CONTRACT NO. DE-AC27-01RV14136 – SUBMITTAL OF U.S. DEPARTMENT OF ENERGY, OFFICE OF RIVER PROTECTION SURVEILLANCE REPORT, S-11-ESQ-RPPWTP-024, ANALYTICAL LABORATORY (LAB) RADIOACTIVE LIQUID WASTE DISPOSAL (RLD) SYSTEM FLOOR DRAINS

Surveillance Report, S-11-ESQ-RPPWTP-024,
for the
WTP Analytical Laboratory Radioactive Liquid Waste
Disposal System Floor Drains

LAB FLOOR DRAINS SURVEILLANCE (S-11-ESQ-RPPWTP-024)

S-11-ESQ-RPPWTP-024, Analytical Laboratory Radioactive Liquid Waste Disposal System Floor Drains

Figure 2

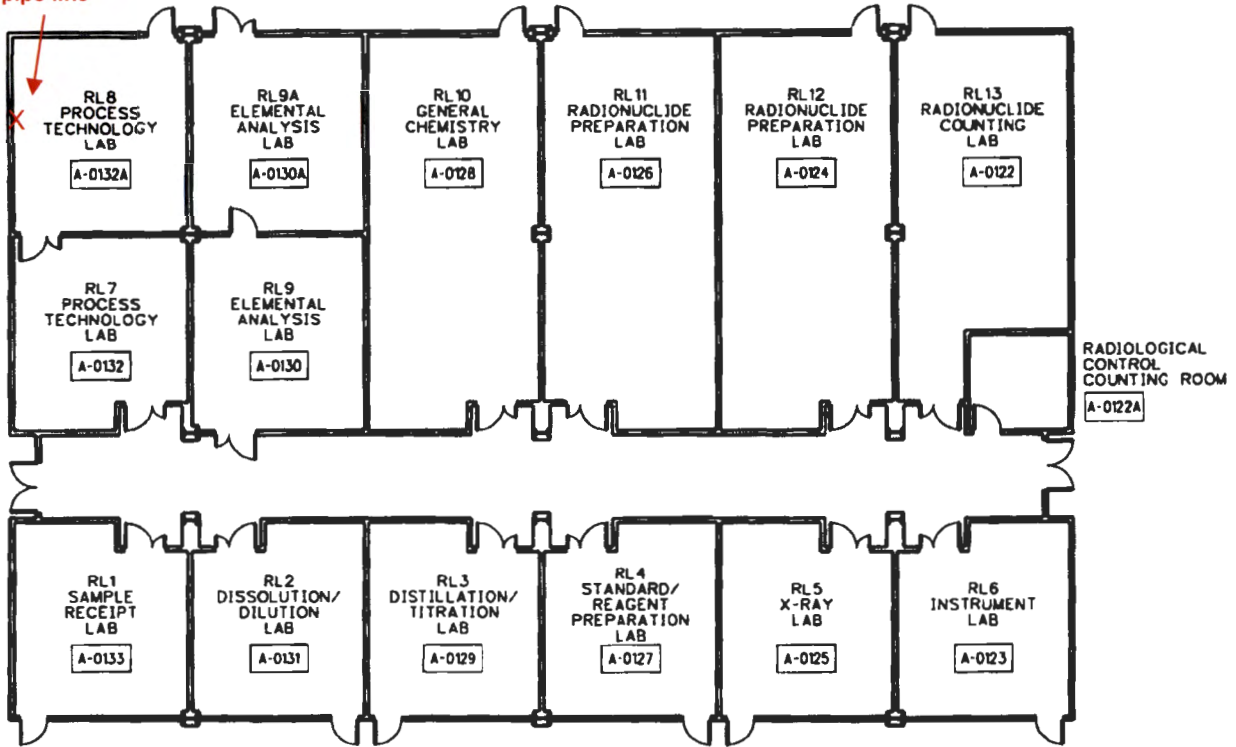
Fume hood ARL-HOOD-00011 drain pipe line LAB-RLD-WU22099001-B was randomly selected (see Figure 1) in the Radiological Laboratories Room A-0132A (see Figure 2) to verify that the requirements (shown in the Surveillance Conformance Summary below) regarding the installation of this drain pipeline were followed. This drain pipeline was also verified in the P&ID, as depicted in Figure 3.

Radiological Laboratories Room Layout (Figure 6-1 from System Description for Fume hood ARL-HOOD-00011 drain pipe line located in top left Room A-0132A). Reference: 24590-LAB-3YD-ARL-00001

ARL-HOOD-00011
drain pipe line

Figure 3
 P&ID – LAB Radioactive Liquid Waste Disposal System C3 Drain Collection Headers, 24590-LAB-M6-RLD-00006001, Revision 0.

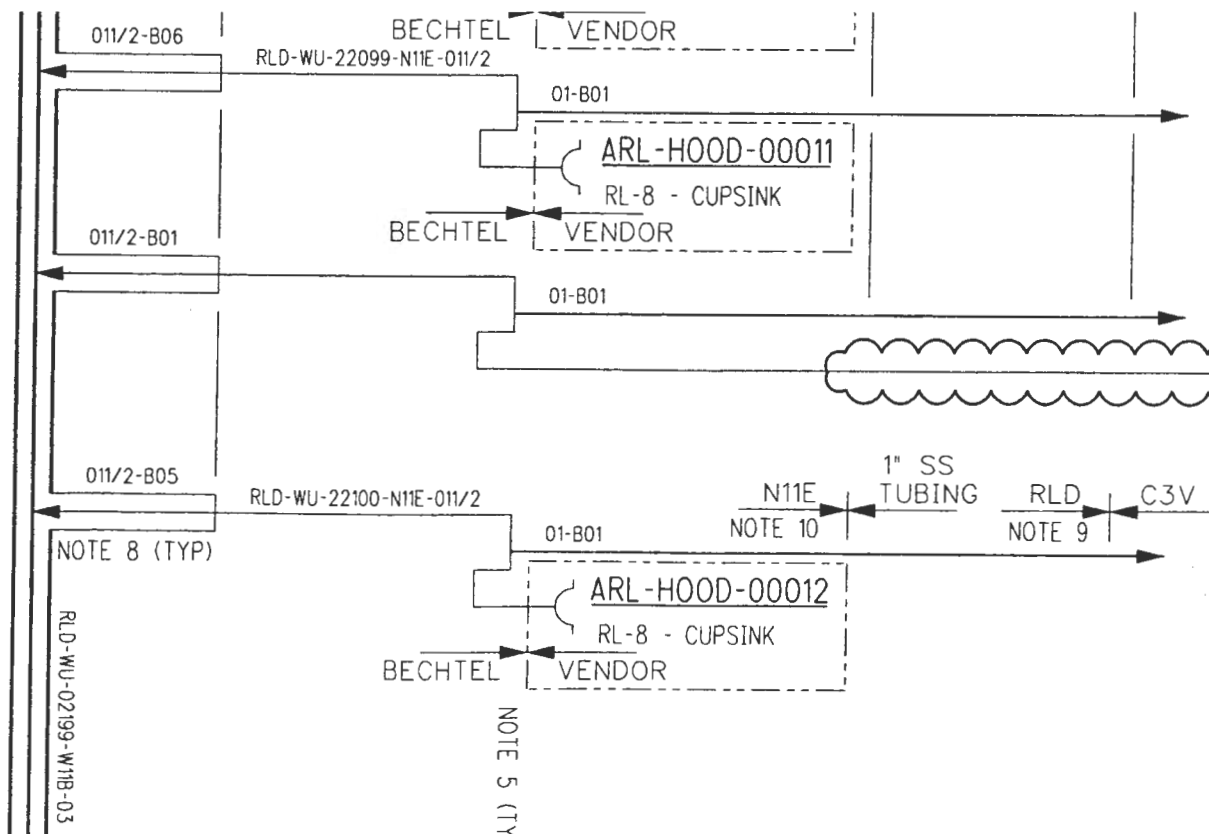
Requirement	Conformance Summary
conditions, stress of installation, and the stress of daily operations (including stresses from nearby vehicular traffic);	
III.10.E.9.b.ii. Design drawings (General Arrangement Drawings in plan and cross sections) and specifications for the foundation, secondary containment, including, liner installation details, and leak detection methodology [Note: leak detection systems for areas where daily, direct, or remote visual inspection is not feasible, will be continuous in accordance with WAC 173-303-640(4)(e)(iii)(C)]. These items should show the dimensions, volume calculations, and location of the secondary containment system, and should include items such as floor/pipe slopes to sumps, tanks, floor drains [WAC 173-303-640(4)(b) through (f), WAC 173-303-640(3)(a), WAC 173-303-806(4)(c)(i)];	The requirement for containment and detection of releases for the piping design was met. The in-slab dangerous waste lines have a minimum slope of 1/16 in. per foot (1:192 slope). These lines all slope toward a vessel cell. The Leak Detection Box is connected to the low point of the double-wall piping where it terminates in the vessel cell.
